HICKOK 539B/C
BIAS FUSE MODIFICATION
By William Eccher

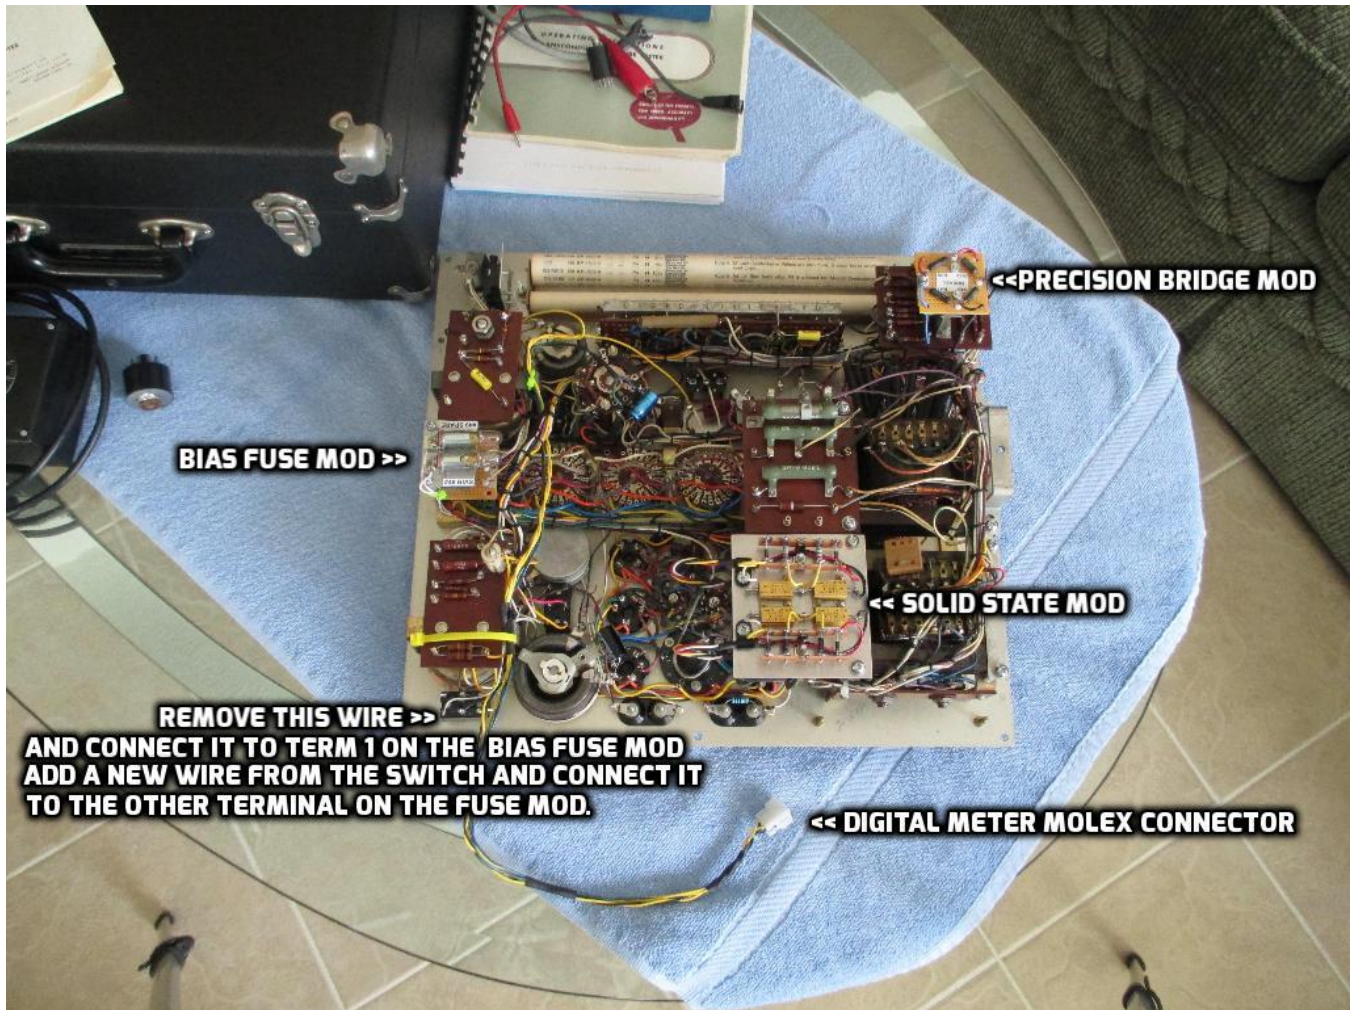
This version has two bayonet socket mounted on a small plate that attaches to the existing machine screws on standoff's next to the Filament Selector Switch. The type 49 bulbs is installed with one bayonet socket wired in in series with the common bias adjust circuit. The other socket holds the spare #49 bulb.

**REMOVE THIS WIRE >>
AND CONNECT IT TO TERM 1 ON THE BIAS FUSE MOD
ADD A NEW WIRE FROM THE SWITCH AND CONNECT IT
TO THE OTHER TERMINAL ON THE FUSE MOD.**
